**SUBJECT:** Invitation for Bid #10-3612-OV  
Lincoln Park Splash Pad & Restroom Pavilion  
501 17<sup>th</sup> Street East, Palmetto, FL

## ADDENDUM #1

**Ugarte & Associates, Inc. Memorandum dated November 10, 2010** responding to questions received at the Pre-Bid / Information Conference held on October 20, 2010 and questions received from contractors and suppliers through November 5, 2010. Ugarte Memorandum lists all revised drawings, Health Department Comments and revised submission sketches which are made a part of this Addendum No. 1. (42 Total Pages)

SCALE	NONE	PIPE SCHEDULE
PROJECT NO.	00489	
DATE	10/20/2010	
DRAWN BY	AMJ	SKPL5.10-3
CHECKED BY	SAL

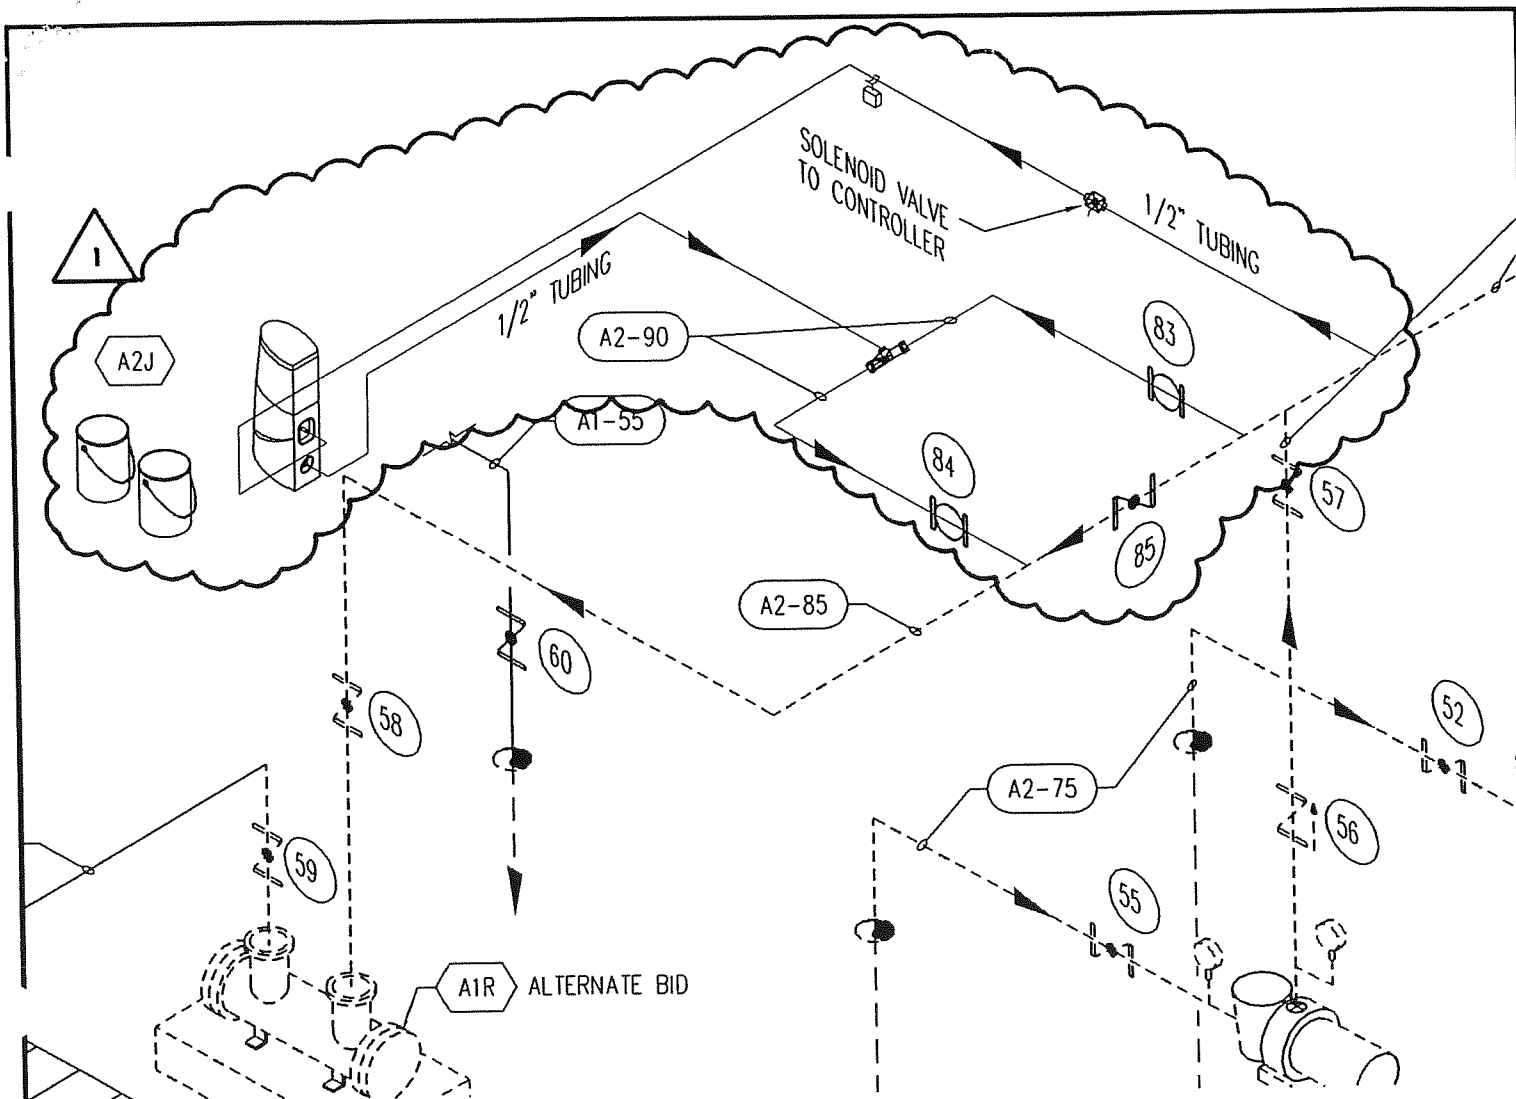
7. A Pulsar one chlorine injection system has been specified in lieu of the Hayward system to comply with 64E-9.007(16) with chemical loop and venturi system. Please see attached sketch **#SKPL5.10-1, #SKPL5.10-3, #SKPL5.10-4, #SKPL4.02-8** and revised equipment list on sketch **#SKPL4.00-4**.
8. The UV validation certificate and additional information has been attached to this submittal package for your reference and are in compliance with 64E-9.007(16)(f)3.
9. The UV equipment specified is in compliance with 64E-9.007(16)(f)(4). A note has been added to the UV equipment list as shown on attached Sketch **#SKPL4.00-4**

LINCON PARK WATER TANK PLAN

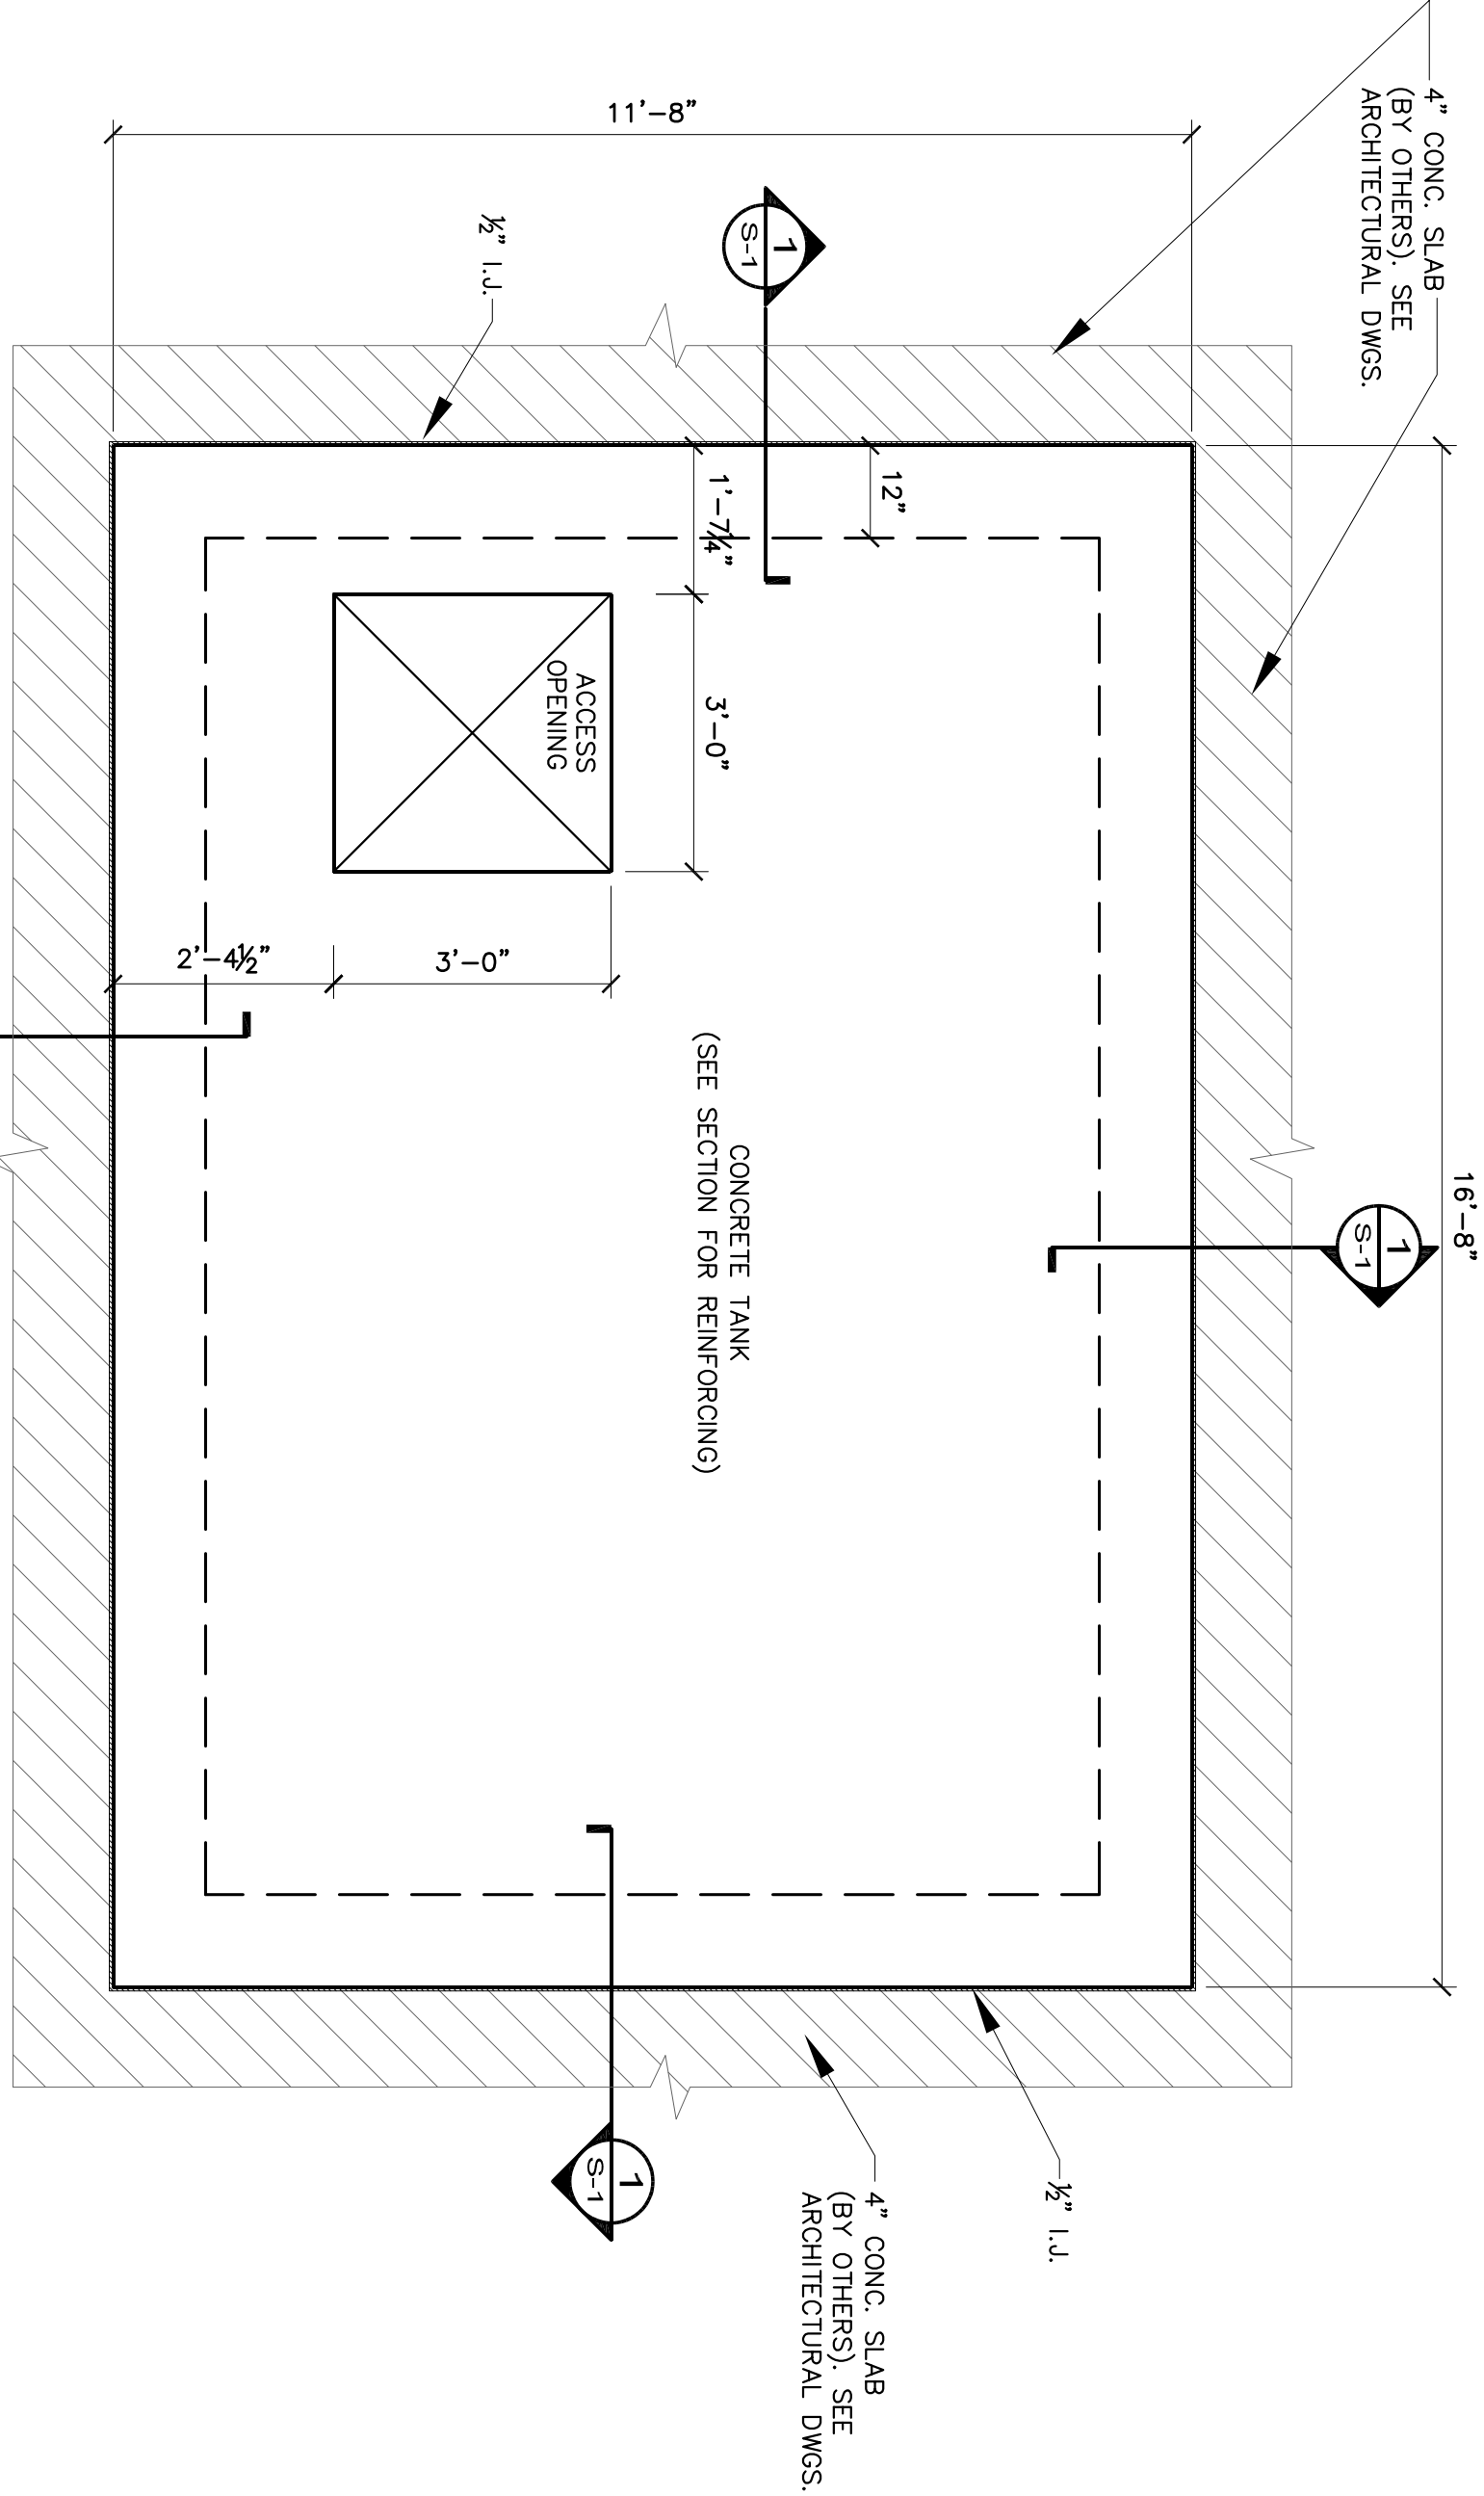
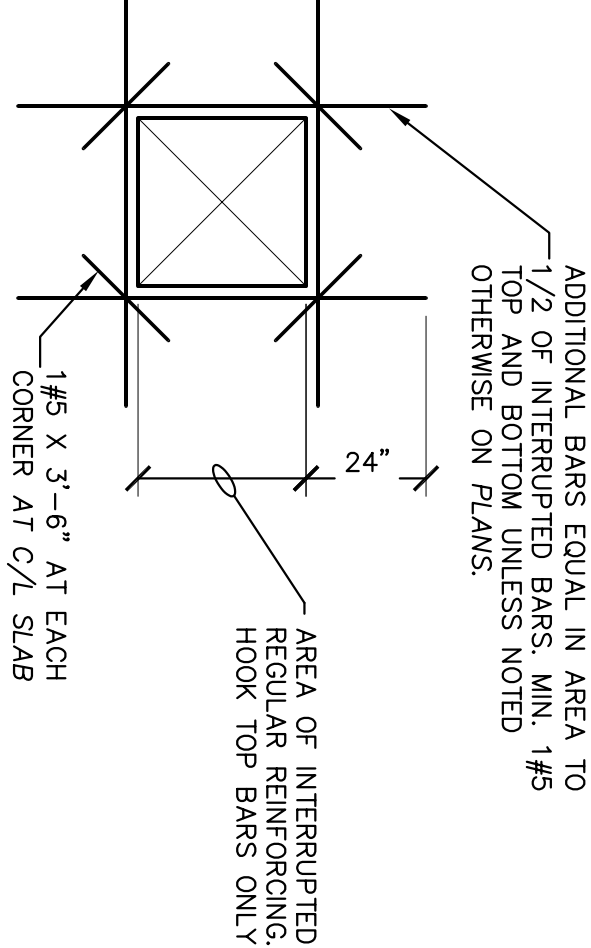
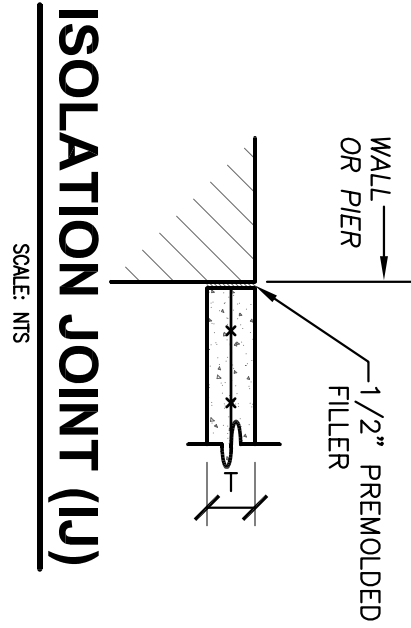
**PBC Question #2:** Can an alternate surge tank design method be used to the Cast-in-Place concrete as shown on the bidding plans?

**PBC Response #2:** Contractor to bid in accordance with the plans and specifications See attached Addendum #1 sheet S1 Addendum 1.pdf.
